# MECKLENBURG COUNTY
## Health Department

Re: Application for improvement permit for: 3 Bedroom House
Property Location: 7617 Denbur Dr., Charlotte, NC 28215 (PID 111-451-04)
Health Department File Number: **12701 (App 8749)**

Sheet: 1 of 2
Property ID: 111-451-04
Lot #: 11
File #: 12701
AppID: 8749

# SOIL/SITE EVALUATION
# for ON-SITE WASTEWATER SYSTEM

**Sketch of Soil Evaluation Locations**

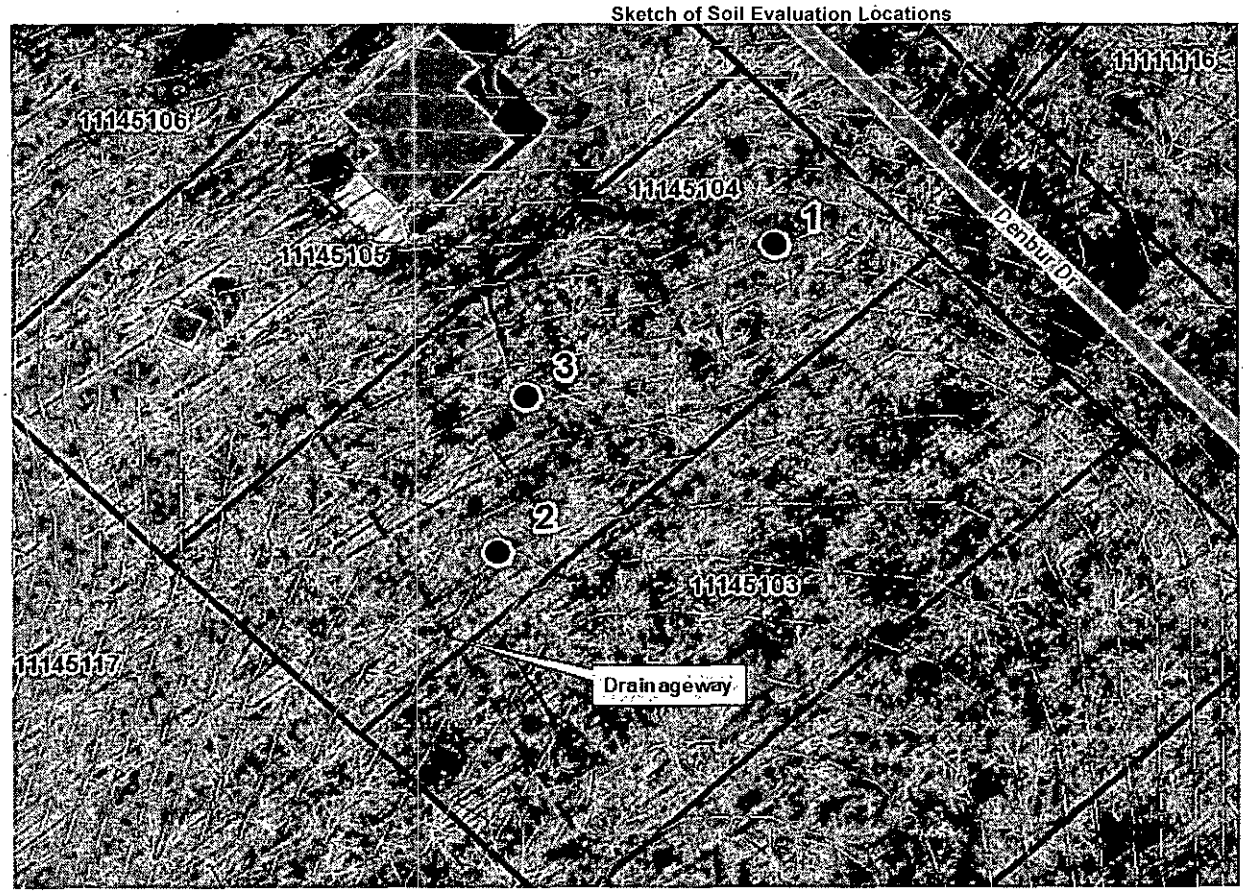
Based on the criteria set out in Title 15A, Subchapter 18A, of the North Carolina Administrative Code, Rules .1940 through .1948, the evaluation indicated that the site is **UNSUITABLE** for a ground absorption sewage system. Therefore, your request for an improvement permit is **DENIED.** A copy of the site evaluation is enclosed. The site is unsuitable based on the following:

- ☒ Unsuitable soil topography and/or landscape position (Rule .1940)
- ☒ Unsuitable soil characteristics (structure or clay mineralogy) (Rule .1941)
- ☒ Unsuitable soil wetness condition (Rule .1942)
- ☒ Unsuitable soil depth (Rule .1943)
- ☐ Presence of restrictive horizon (Rule .1944)
- ☒ Insufficient space for septic system and repair area (Rule .1945)
- ☐ Unsuitable for meeting required setbacks (Rule .1950)
- ☐ Other (Rule .1946)

| PROFILE # | .1940 Landscape Position/ Slope% | Horizon Depth (IN.) | SOIL MORPHOLOGY .1941 .1941 Structure/ Texture | SOIL MORPHOLOGY .1941 .1941 Consistence Mineralogy | b PROFILE FACTORS .1942 Soil Wetness/ Color | .1943 Soil Depth (IN.) | .1956 Sapro Class | .1944 Restr Horiz | General Comments | Profile Class & LTAR | Maximum Trench Bottom Depth for 3' Wide Conventional Trench |
|---|---|---|---|---|---|---|---|---|---|---|---|
| Boring #1 | LS 9% | 0 - 5 | sbk SCL | SS SP FR SEXP | 2 chroma at 25" | 25 | NA | NA | | US | NA |
| Boring #2 | LS 11% | 0 - 3 | gr SCL | SS SP FR SEXP | >27" | 19 | NA | NA | | US | NA |
| Boring #3 | LS 11% | 0 - 3 | gr SCL | SS SP FR SEXP | 2 chroma at 28" | 20 | NA | NA | | US | NA |

| Description | Initial System | Repair System |
|---|---|---|
| Available Space (.1945) | US | |

Other Factors (.1946): NA
Soil Evaluation By: Jacob Presley, LSS, REHS
Others Present:
Site Classification (.1948): Unsuitable
Site Evaluation By: Jacob Presley
Others Present:
